AMENDMENTS TO THE DRAWINGS

REMARKS

A. The Arrangement of Oberhofer Lacks An Undercut Portion In a Panel

Current Application

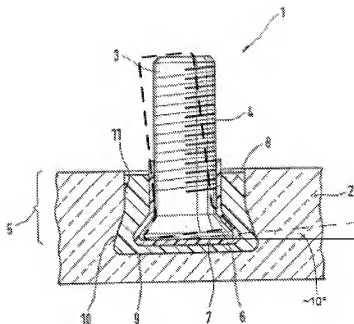
The Examiner objects to the drawing that was submitted in response to the previous Office Action. The Examiner states that the phantom line representing the inclination of the anchor bolt is shown as extending into the curable material (element 8), which is not described in the application as receiving the bolt. A corrected drawing sheet has been submitted.

The Examiner objects to the drawing that was submitted in response to the previous Office Action. The Examiner states that the phantom line representing the inclination of the anchor bolt is shown as extending into the curable material (element 8), which is not described in the application as receiving the bolt. Pursuant to the Examiner's comments, a corrected drawing sheet has been submitted in which the phantom line does not extend into the curable material (element 8), but rather remains within the boundary of the resilient material (element 7). Accordingly, the objection to the drawings should be withdrawn.

Referring to the figure, the fixing element has an anchoring zone 5 having a resilient covering 7 surround by a cured composition 8. The anchoring zone is secured within a drilled undercut hole 9 in the panel, the undercut hole being shaped at wall 11 to prevent detachment or pulling of the fixing element from the panel. As a result, the fixing element in the undercut portion exhibits resilience in all directions, and the resilience enables inclination of the anchor bolt of about 10 degrees without detachment. (See Application at page 2, line 30 to page 3, lines 10.)

FIG. 14

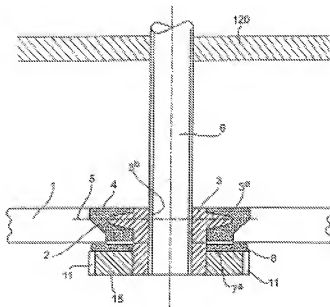
The Examiner states that Oberhofer discloses a glass panel 1 that includes an undercut hole 2. A fixing device includes an anchor bolt having a fixing means 6 and an anchoring zone 3 that widens in cross-section in the direction of insertion. A resilient material 4 permits inclination of the anchoring bolt. The Examiner recognizes that Oberhofer does not specifically disclose an inclination of ten degrees, but concludes that such an inclination amount would be either inherent from the structures or obvious to one of ordinary skill in the art. Applicants disagree with the Examiner's application of Oberhofer.

The fixing device of Oberhofer does not secure the glass panel via **an undercut hole** in the panel that prevents detachment. Element 2 is not an undercut hole because it narrows, rather than widens, as it extends through the glass away from the wall structure 120. Indeed, element 2 of Oberhofer is configured oppositely to the undercut hole 9 in Applicants' invention (see the above figure).

The panel in Oberhofer is configured in this manner because the fixing device is designed to secure "glass plates [that] have borings or holes **cut all the way through**." (E.g., col. 2, lines 30-31.) As seen in the above figure, therefore, in the device of Oberhofer the resilient material 4 extends through the entire glass panel. In such a configuration, the bolt 6 would be subject to pulling through the glass panel. To avoid this, additional structures, such as the nut 15 which screws onto the annular body 3, are provided to secure the bolt in the glass panel. (See, e.g., Oberhofer at col. 7, lines 5-20.) As seen in the above figure, such securing structures protrude through the glass panel, which would be less desirable in look and function than having a smooth outer surface of the panel.

In contrast, in the device of the present invention, the resilient material is wholly within the undercut portion 9, the shape of which prevents the anchoring bolt from pulling out. Oberhofer, therefore, does not anticipate the claimed invention because Oberhofer does not disclose a fixing device that is used in conjunction with an undercut portion of a glass panel.
